RE: RESPONSE TO COUNCIL INFORMATION REQUEST – MCU/2022/242
AT: LOT 502 HOMESTEAD DRIVE, STAPYLTON QLD 4207 (LOT 502 ON SP316137)

We act on behalf of the Applicant, FPI Queensland Pty Ltd, and provide the following response to Council's Information Request received on 23 June 2022. The Applicant considers this a full response to the information requested, and requests Council to proceed with their assessment of the development application.

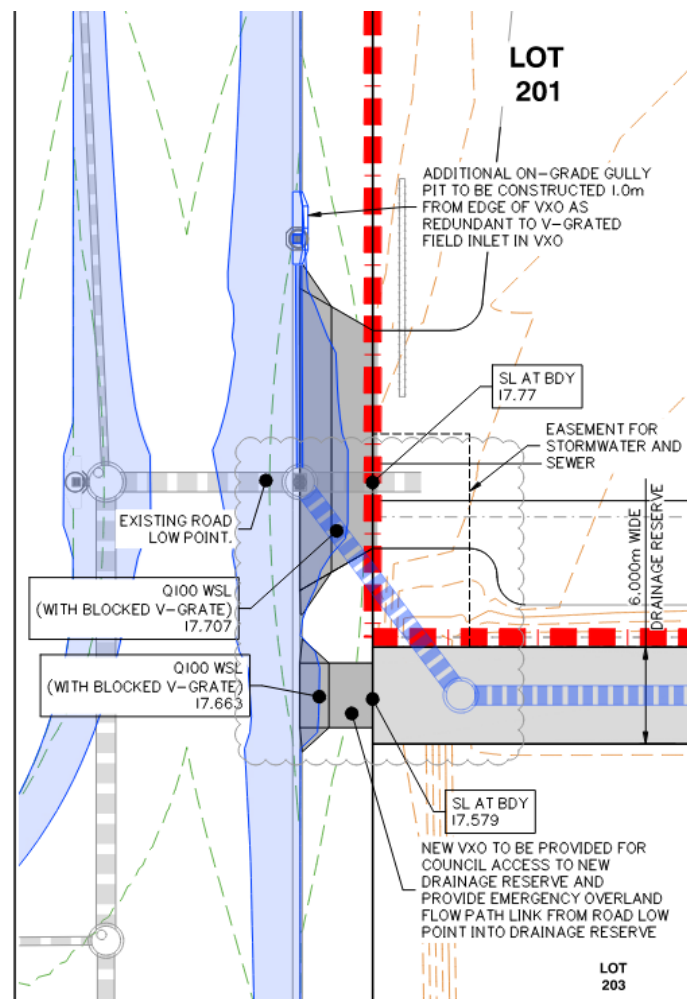
It is understood that no changes have been proposed from the previously approved stormwater management strategy except the stormwater drainage system along the southern boundary of Lot 201 which has been moved further south. Previously it was approved as a drainage easement. Now it is proposed as a drainage reserve to be dedicated to Council.

The drainage reserve has also been proposed to be a 3 metres wide concrete drain to convey stormwater runoff during major storm events and to facilitate Council's access to the end-of-line Council's bioretention and detention basins. Total width of the drainage reserve is 6 metres with a batter slope of 1 in 2. The drainage reserve will also accommodate a stormwater pipe and a sewer pipe. However, the proposed relocated drainage system included two major bending to connect with the already constructed stormwater inlet and outlet systems.

Council's officers envisage that the proposed bends will cause hydraulic head loss and will increase the erosion potential. Therefore, the applicant is requested to demonstrate that the additional head losses will not cause any unacceptable hydraulic impact / nuisance on upstream roads. The applicant is also requested to demonstrate that adequate erosion protection measures have been implemented at these bends.

In response to this item, Council officers' concerns are acknowledged and were addressed through the submitted amended SWMP (Rev. 5 dated 31 May 2022) as part of the minor change application to the Stage 2 ROL (Council ref: MIN/2022/245) associated with the increase in size to Lot 201 of the Vantage development.
